**TOWN OF WINTER PARK
PLANNING COMMISSION
Tuesday, July 26, 2022 8:00 AM**

TO Planning Commission
FROM Hugh Bell, Planner
THRU James Shockey, Community Development Director
DATE July 26, 2022
RE PUBLIC HEARING: Special Use Permit Request – 1097 Winter Park Drive – Blackjack Cannabis (PLN22-077)

RE PUBLIC HEARING CONTINUED: Final Development Plan (FDP) - Cooper Creek Village, Cooper Creek North, and Cooper Creek South (PLN21-082)

LOCATED IN THE TOWN OF WINTER PARK,
COUNTY OF GRAND, STATE OF COLORADO
EXISTING ZONING

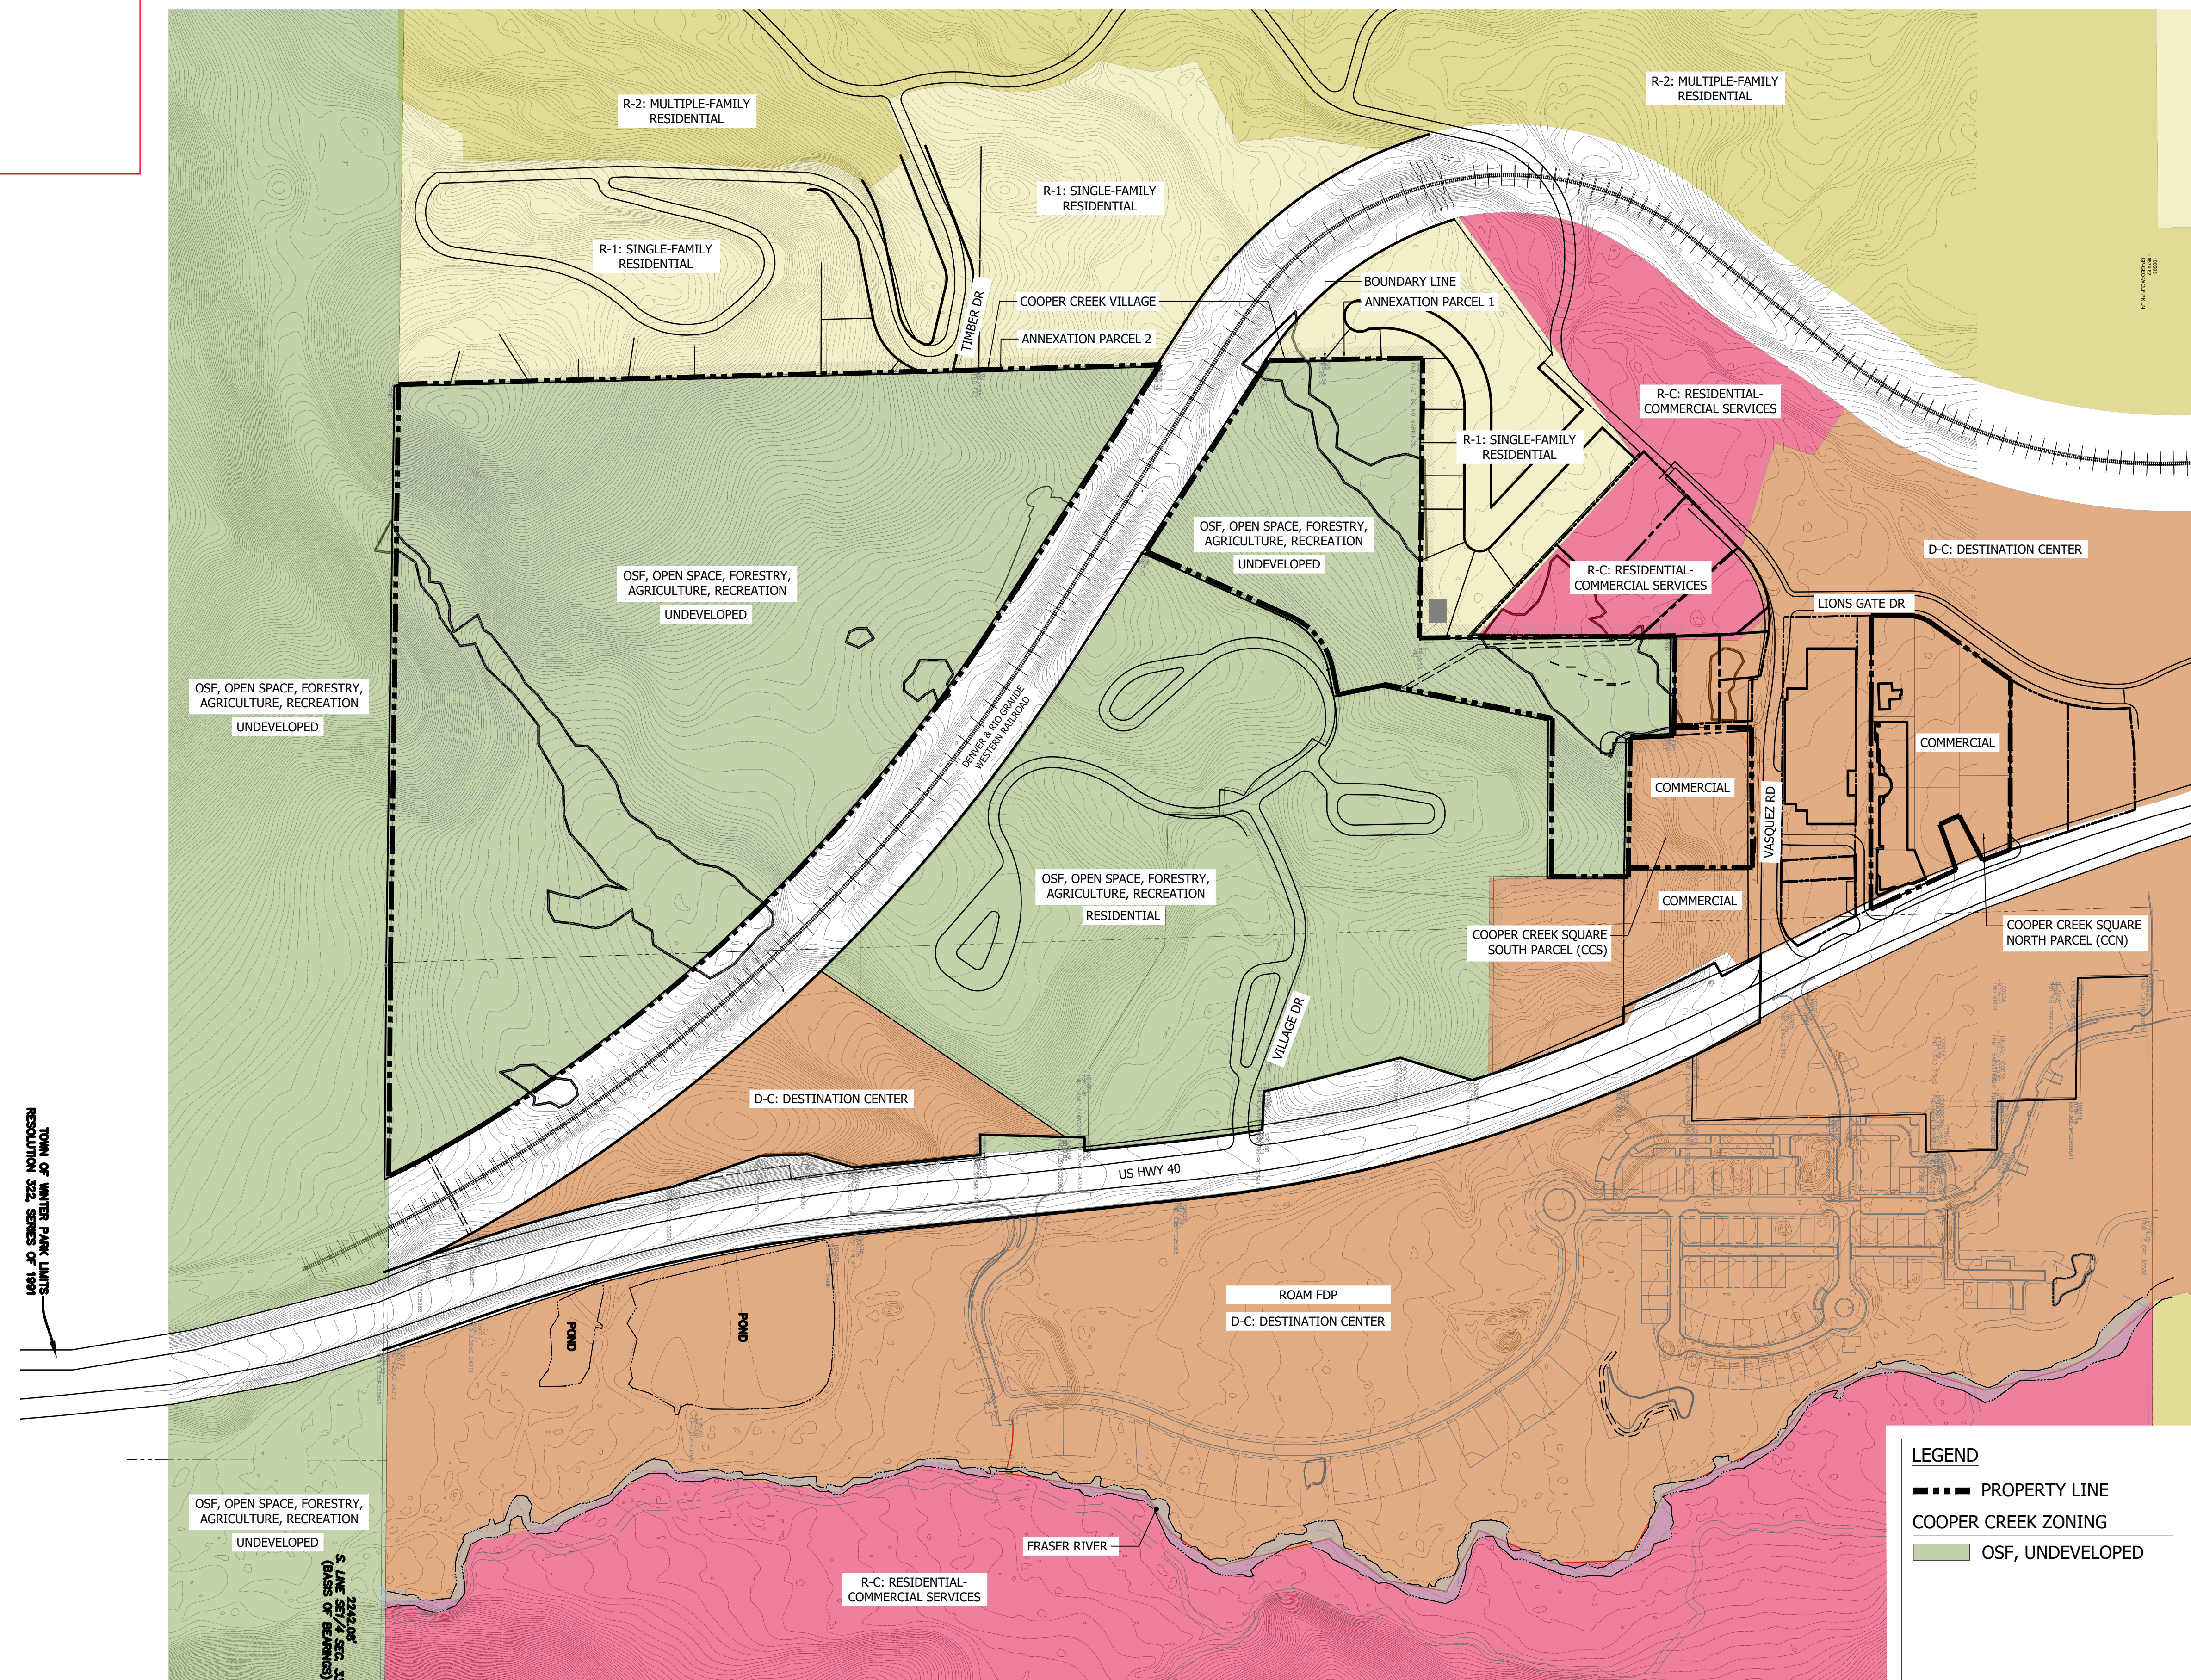
This map can be deleted.

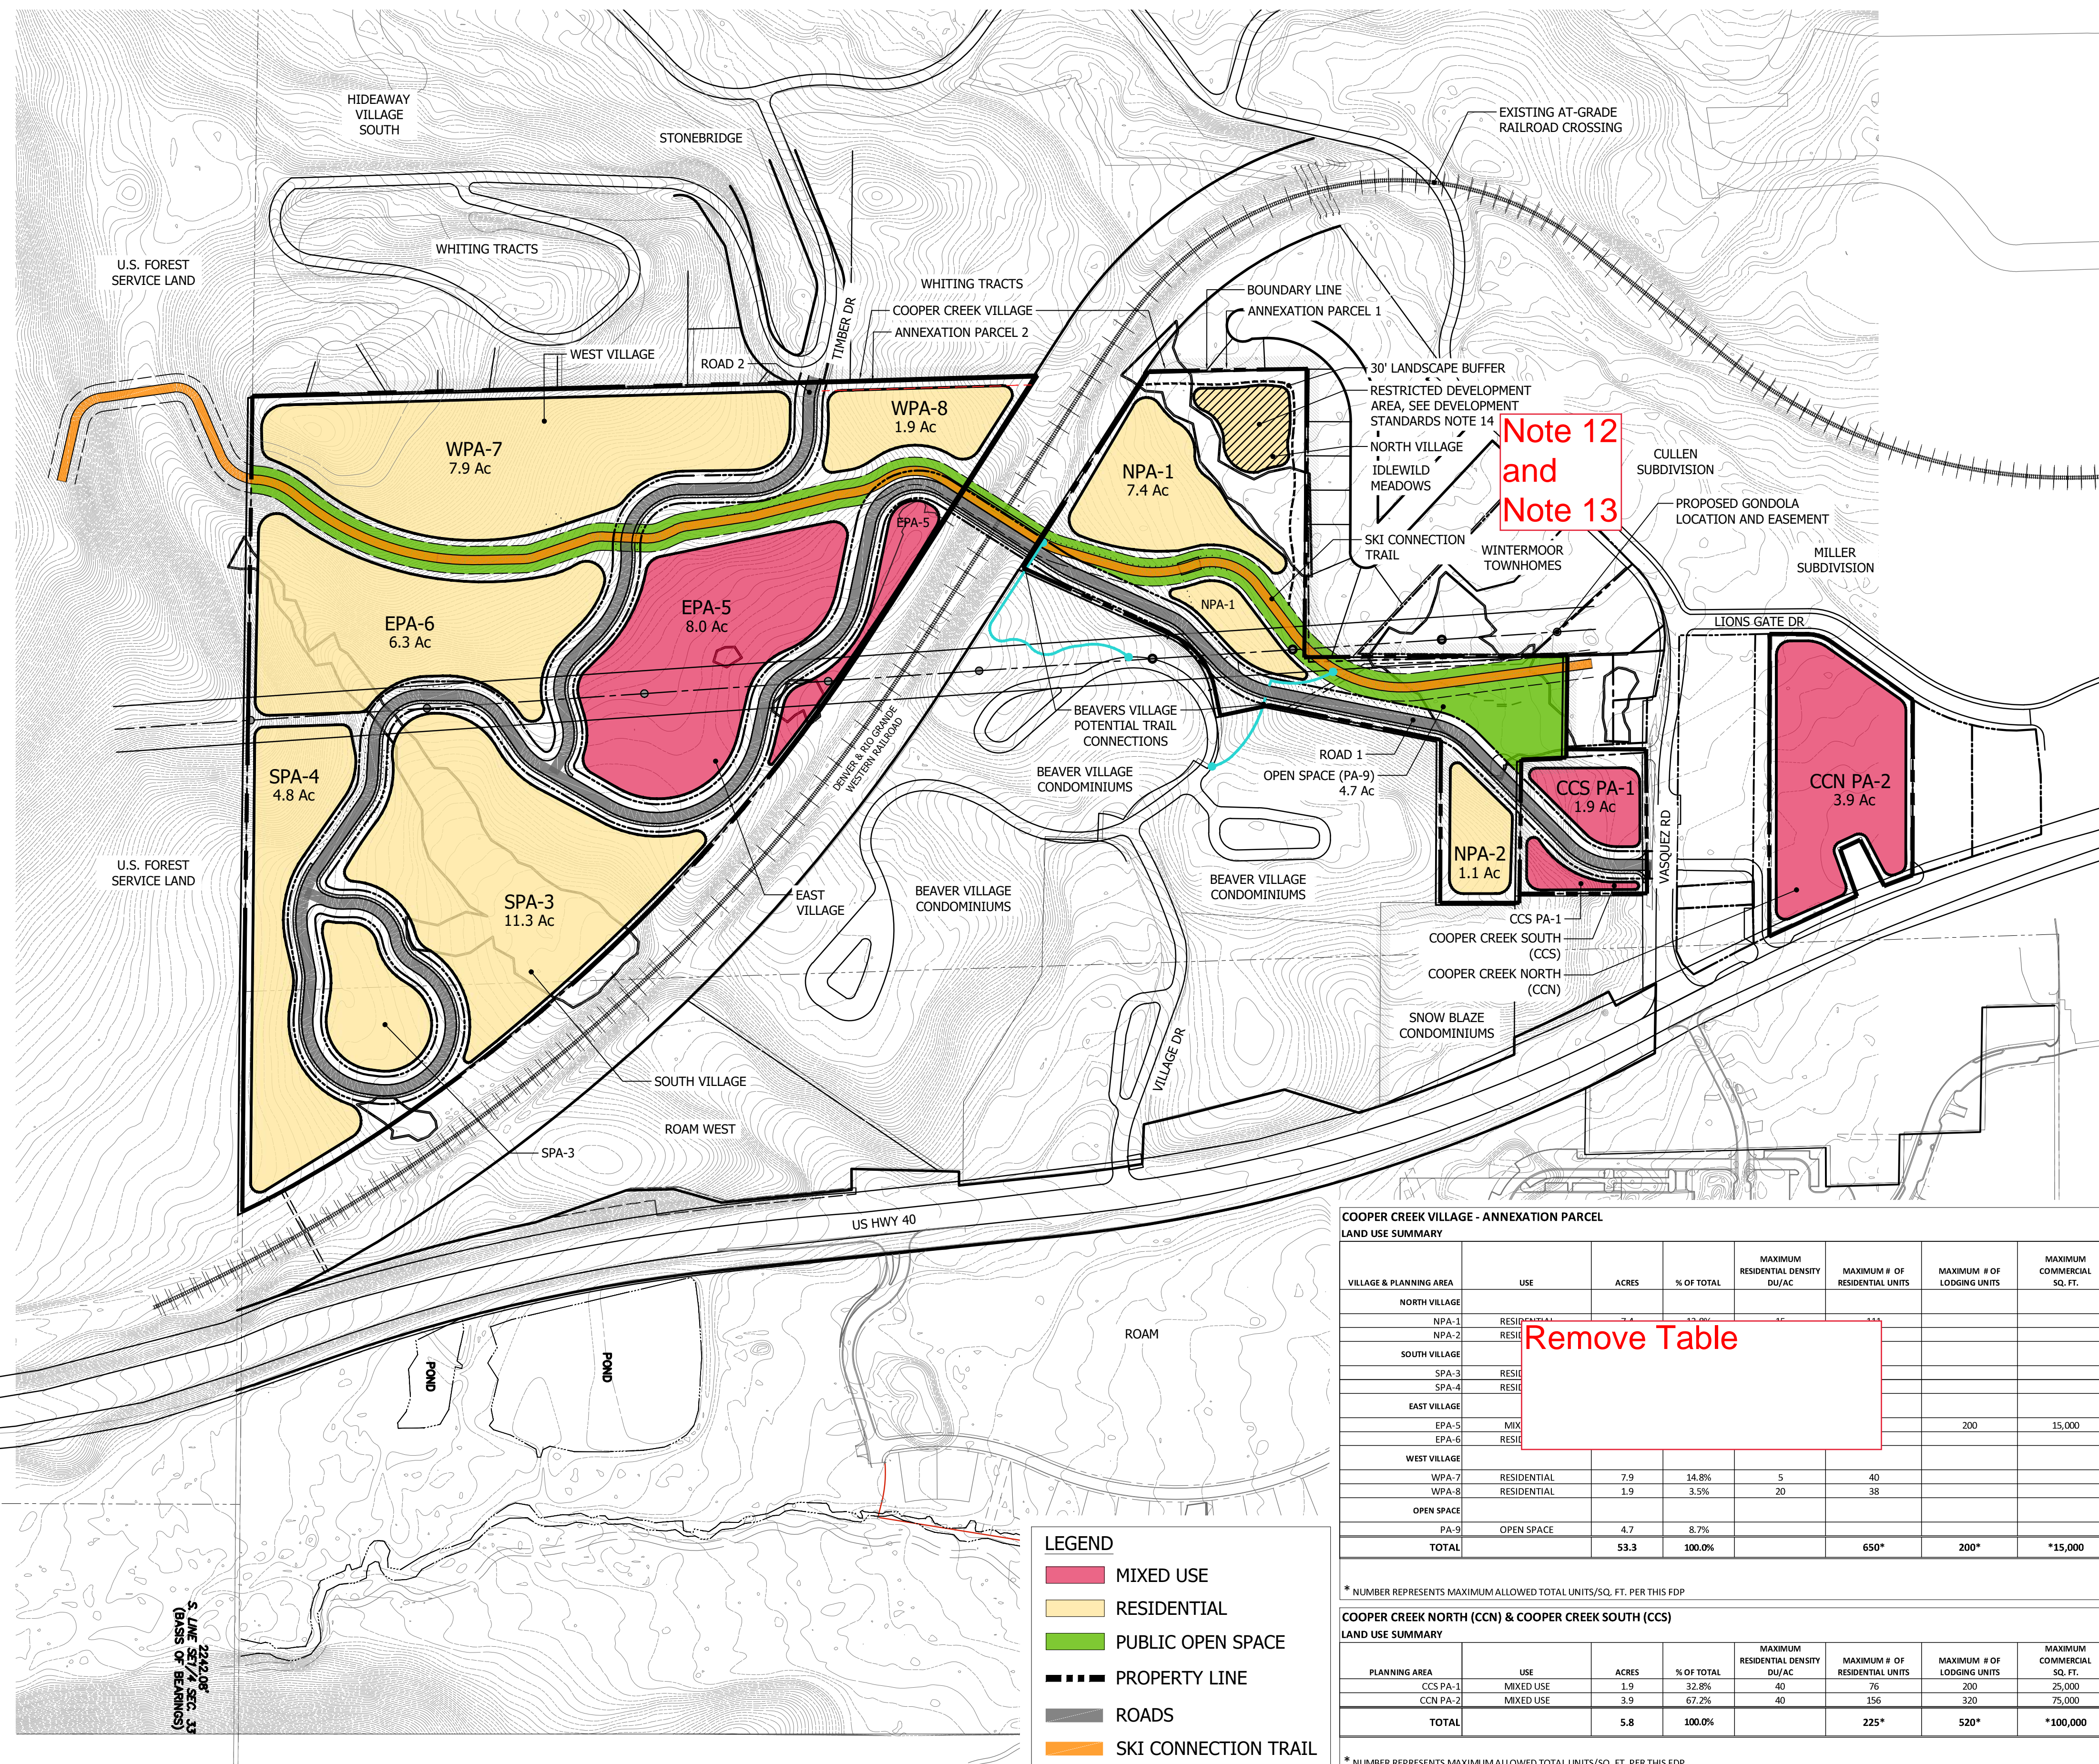
Update to show all 11 parcels being annexed as background to the planning areas

Add base zoning to the different planning areas. It can be just added as DC or RC under the planning area designation.
Example
WPA-7
RC Base Zone
7.9 Ac

LOCATED IN THE TOWN OF WINTER PARK,
COUNTY OF GRAND, STATE OF COLORADO
OPEN SPACE AND TRAILS PLAN

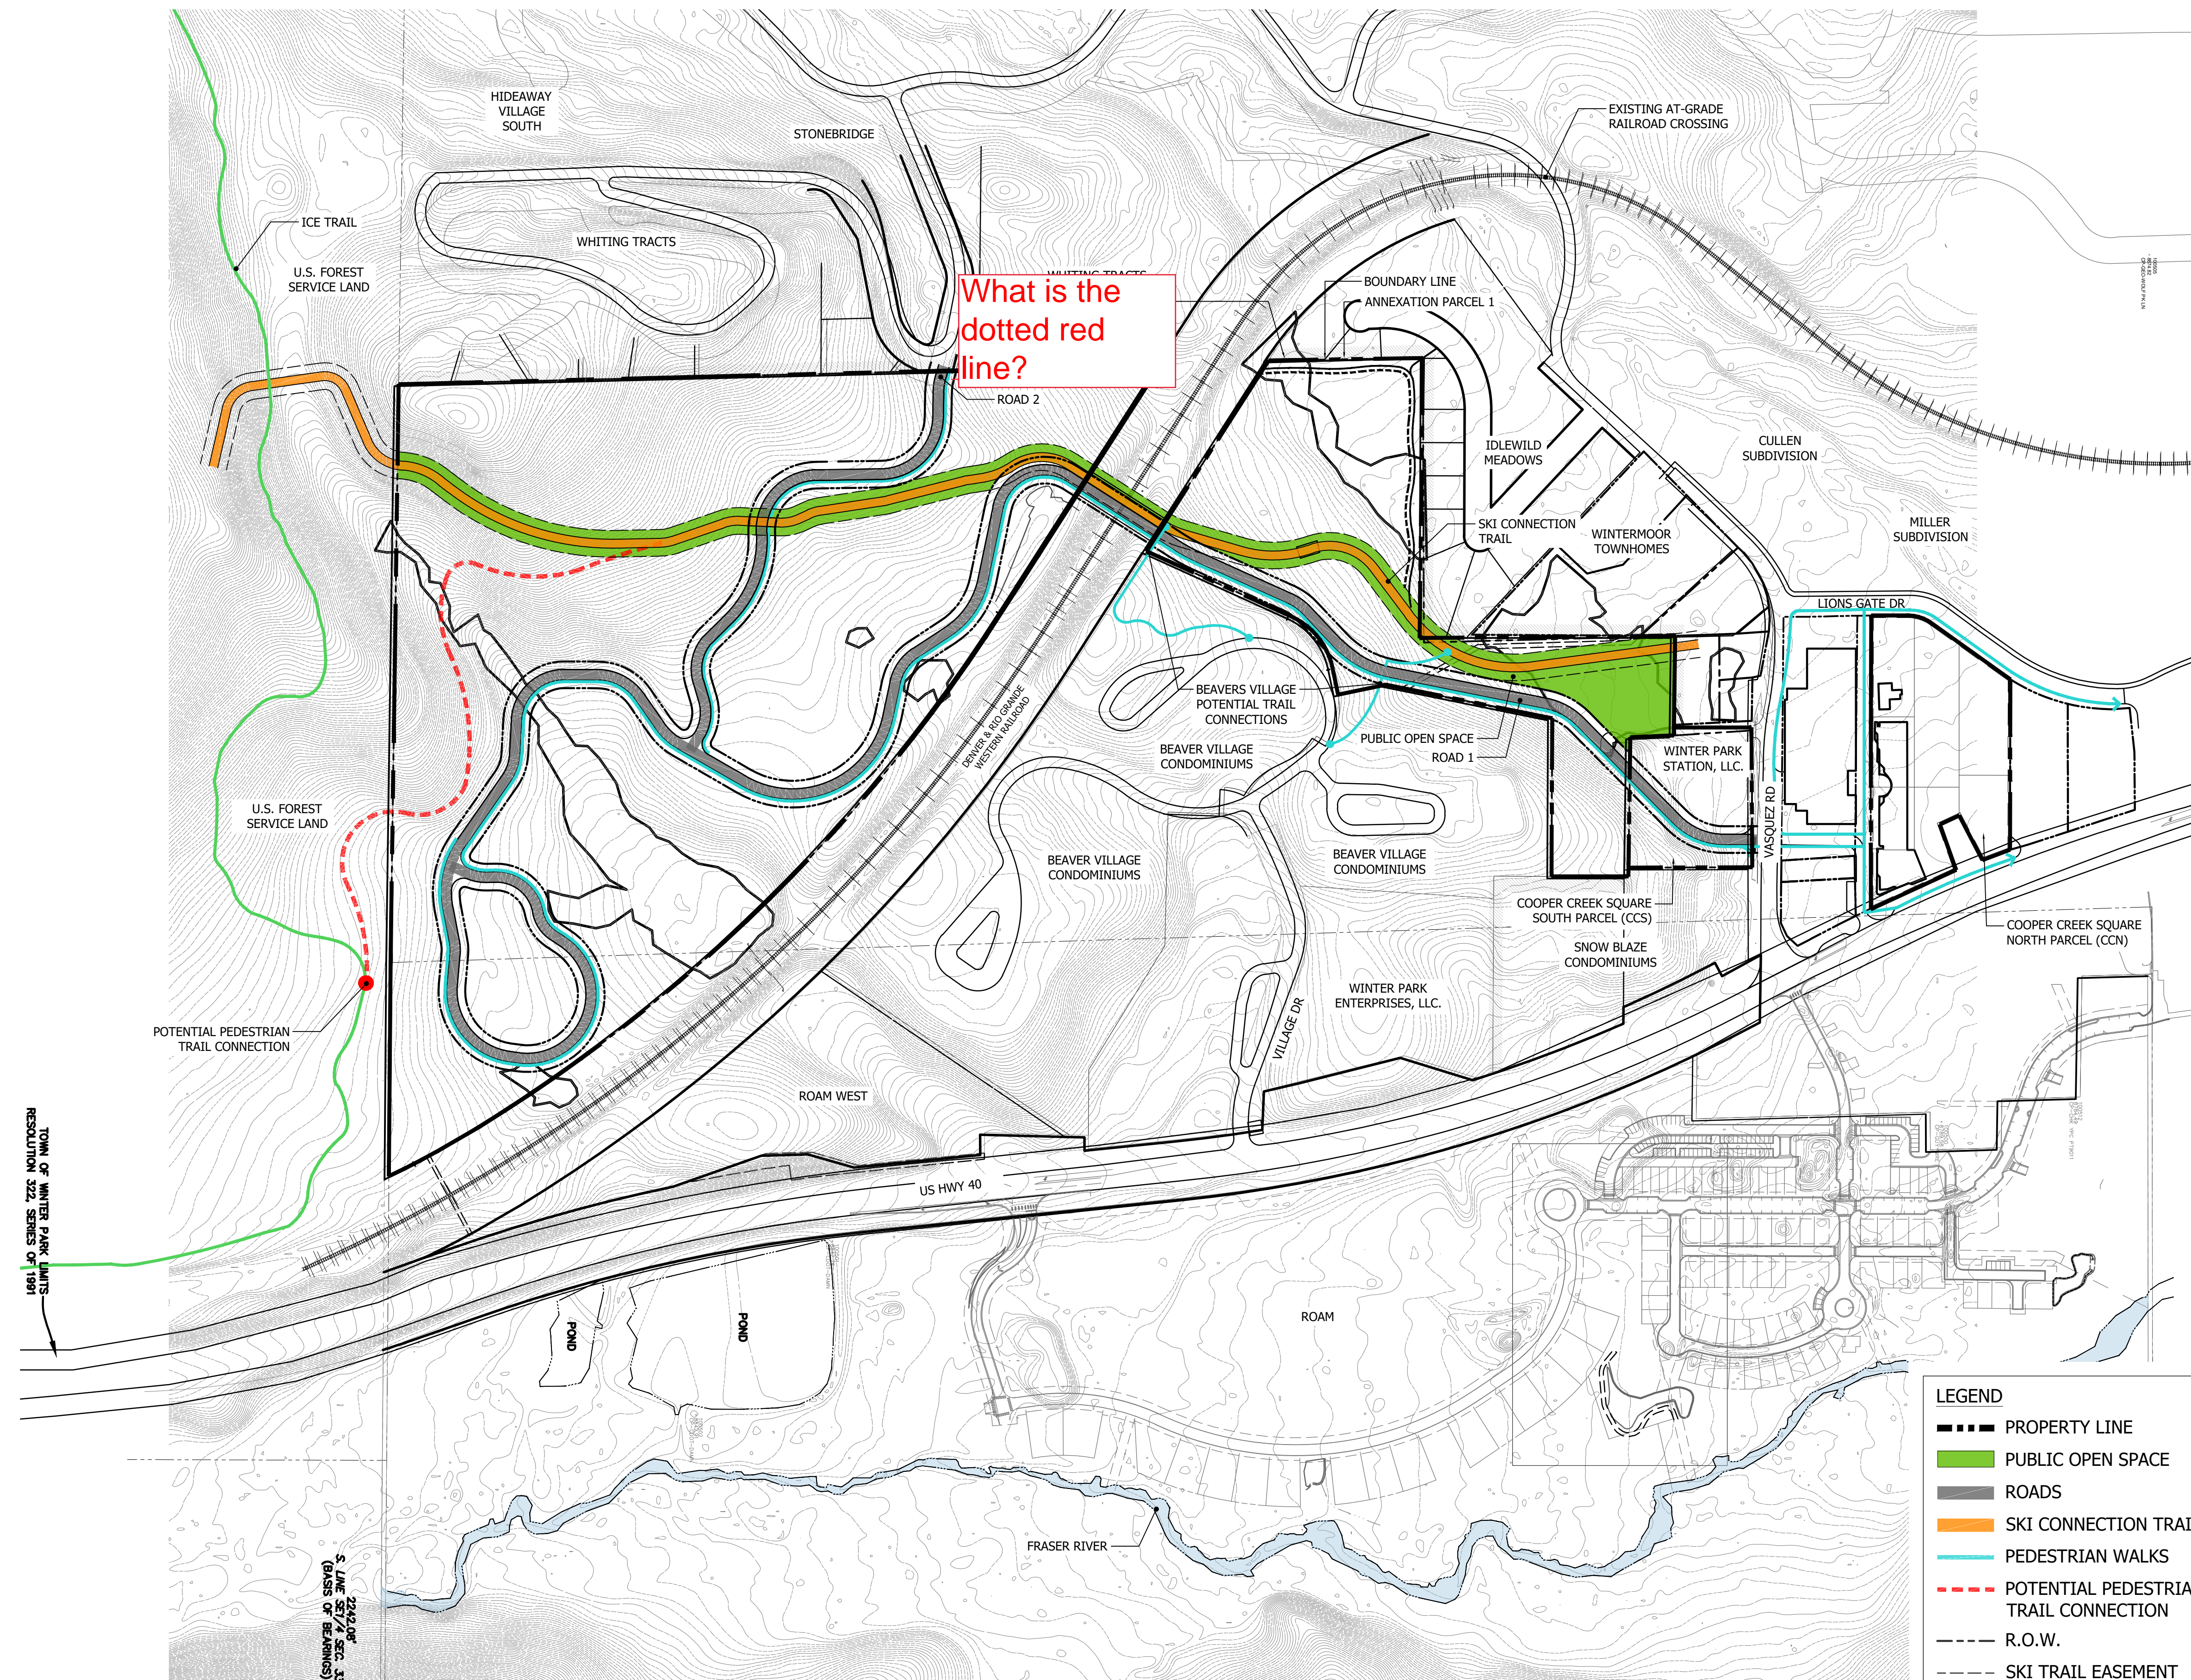
What is the dotted red line?
